James R. Morrissey  
Attorney

Re: **DOCKET NO. 465** – The United Illuminating Company Application for a Certificate of Environmental Compatibility and Public Need for the Construction, Maintenance, and Operation of a 115/13.8-Kilovolt Replacement Substation Facility Located on an Approximately 1.5 Acre Portion of Two Adjoining UI-Owned Parcels Directly Adjacent to UI's Existing Baird Substation, 1770 Stratford Avenue, Stratford, Connecticut, and Related Transmission Structure and Interconnection Improvements – **Request for D&M Modification**

SITE PLAN					
BAIRD SUBSTATION					
<b>ui</b> The United Illuminating Company	Drawn	Date	04/29/2015	Scale: 1"=40'	CAD FILE NAME
	Chkd.	Design Engr.	Design Supv.		SEQUENCE No. 094095 DRAWING NUMBER 25253-401

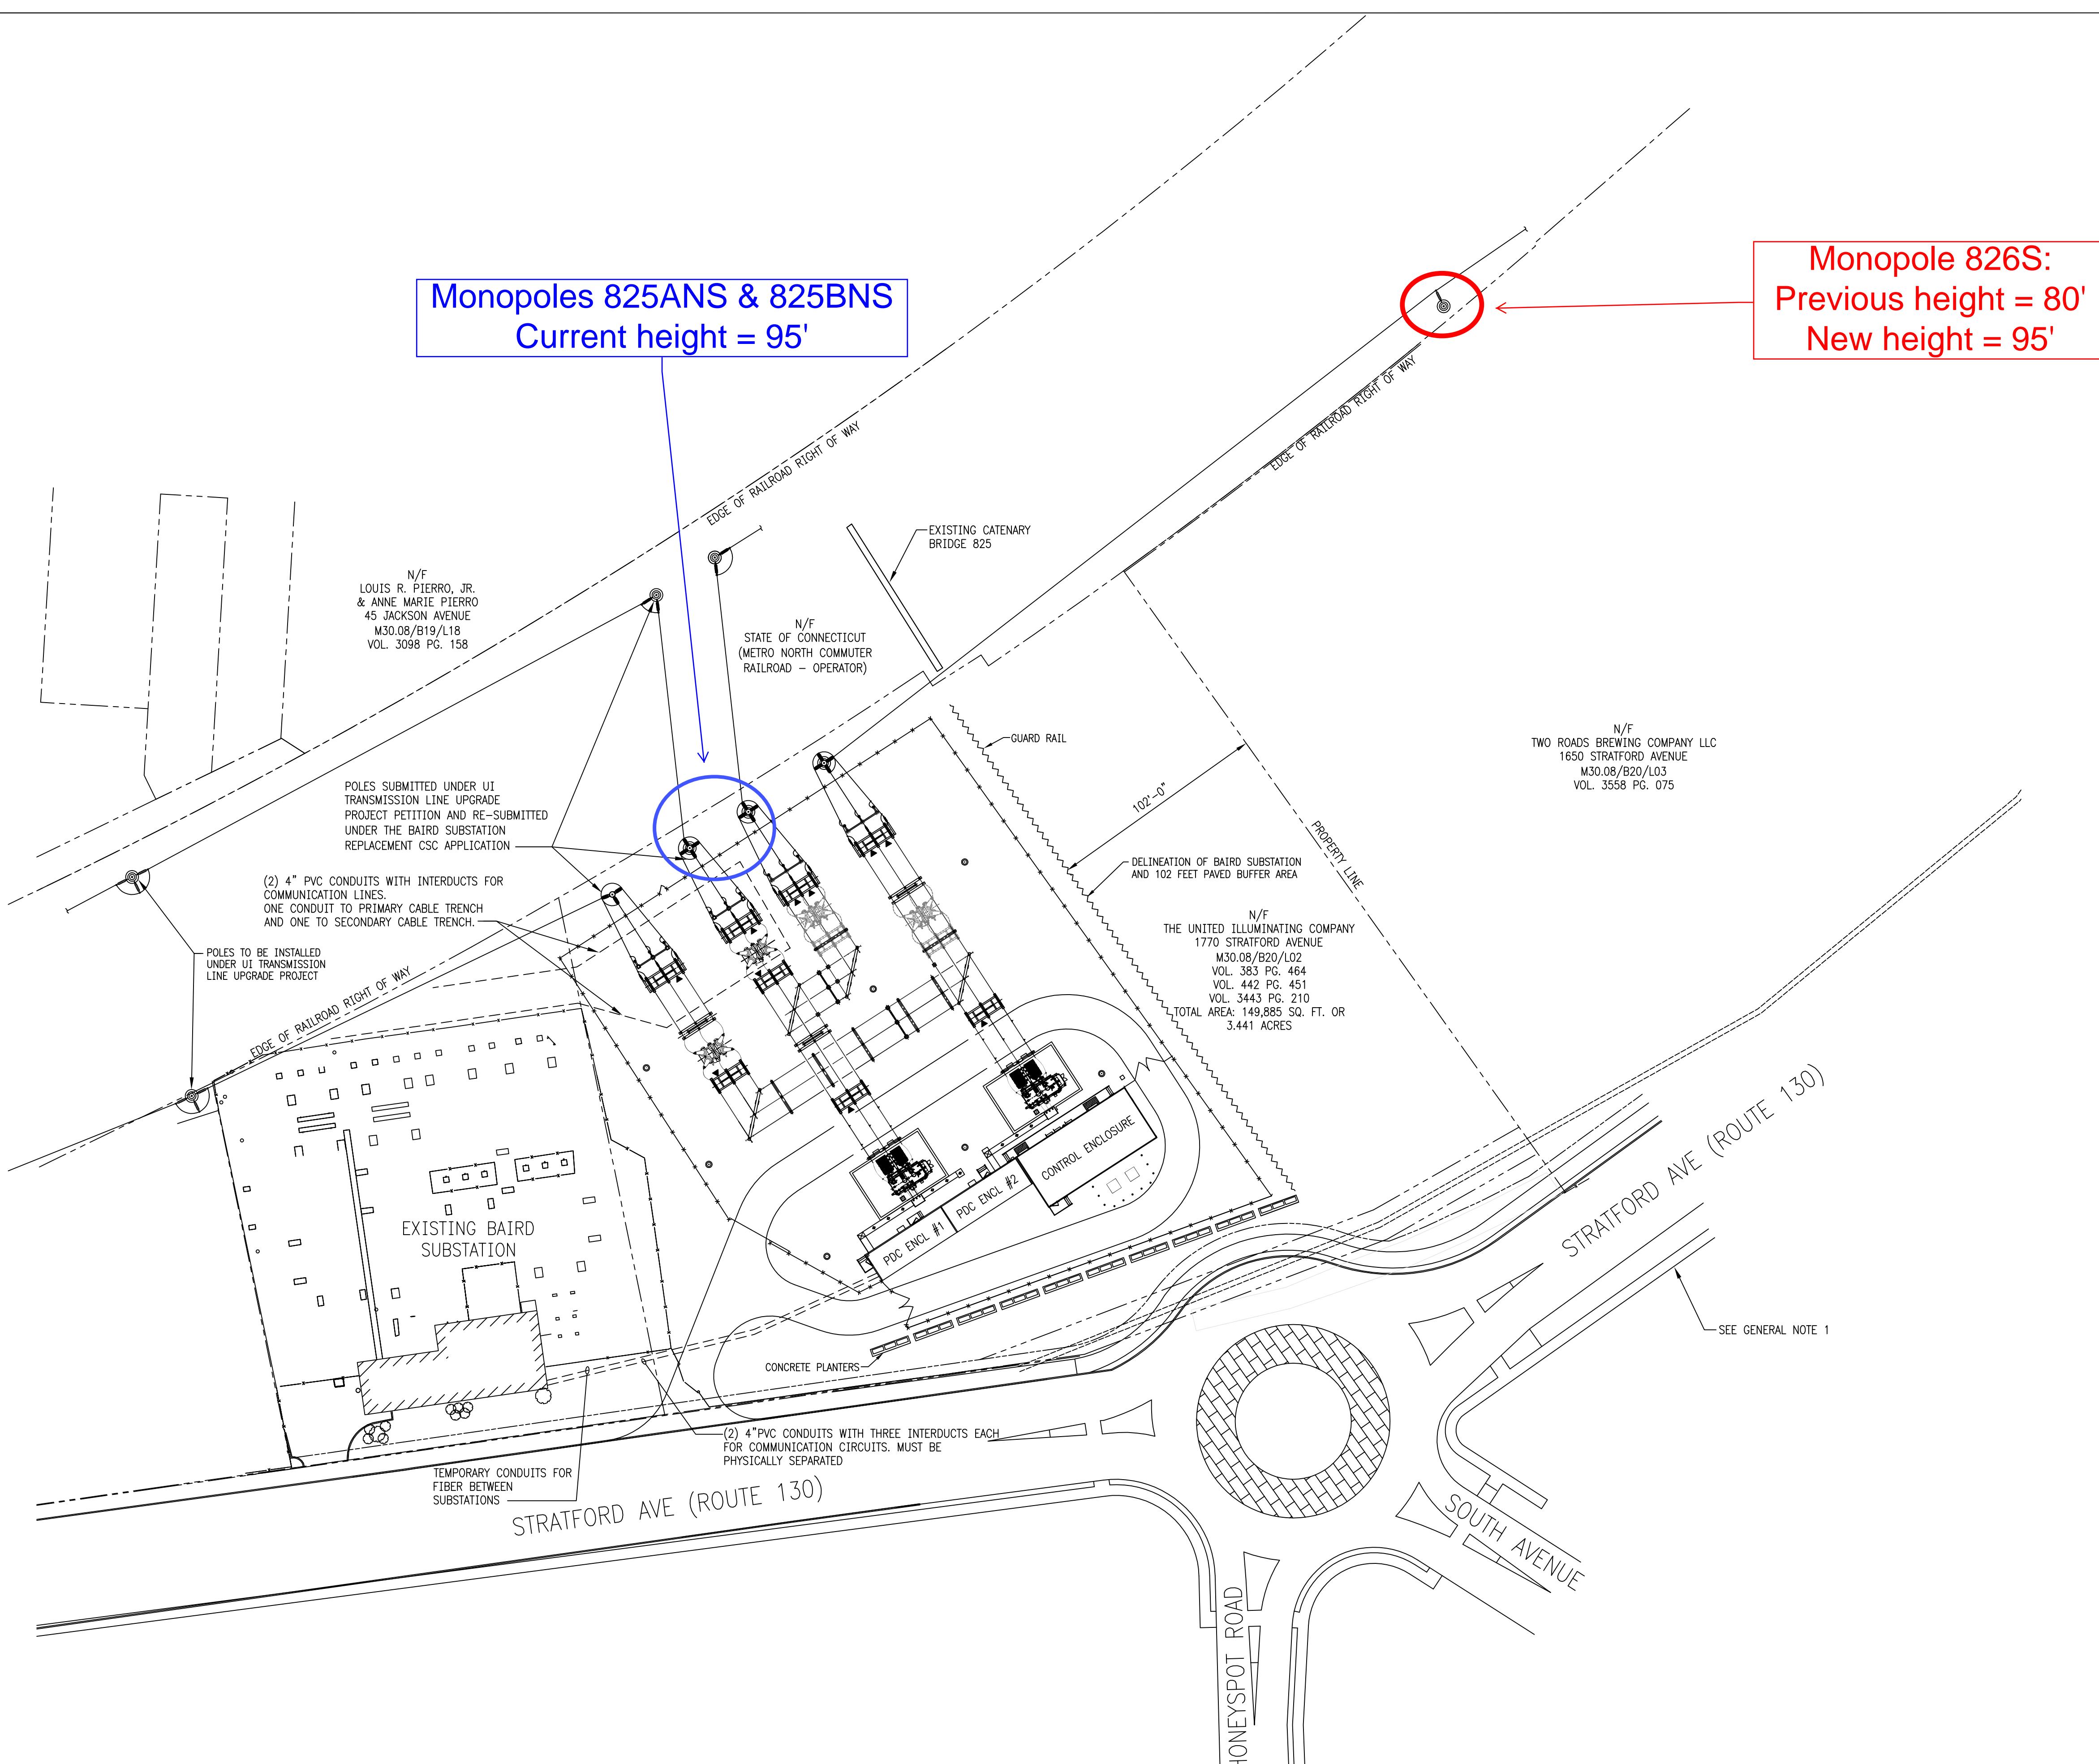
The Company hereby requests, in accordance with the Regulations of Connecticut State Agencies § 16-50j-62(b), that the Council approve a minor modification of the aforementioned D&M Plan. Specifically, UI requests permission to increase the height of the monopole referred to as “826S” from 80 to 95 feet. This change is more particularly described in a drawing included with this request and labeled Attachment A. The Company does not believe that this request represents a significant change as at 95 feet, monopole 826S will be equal in height to two other poles associated with this project. UI is confident that this request will not result in a significant change to the overall visual impact of the project.

The Company requests permission to increase the height of monopole 826S: (1) to avoid encroachment on the Two Roads Brewery property (an abutter), that would restrict the use of portions of the brewery property and require an easement; and (2) to ensure proper clearances from Metro North Railroad conductors.
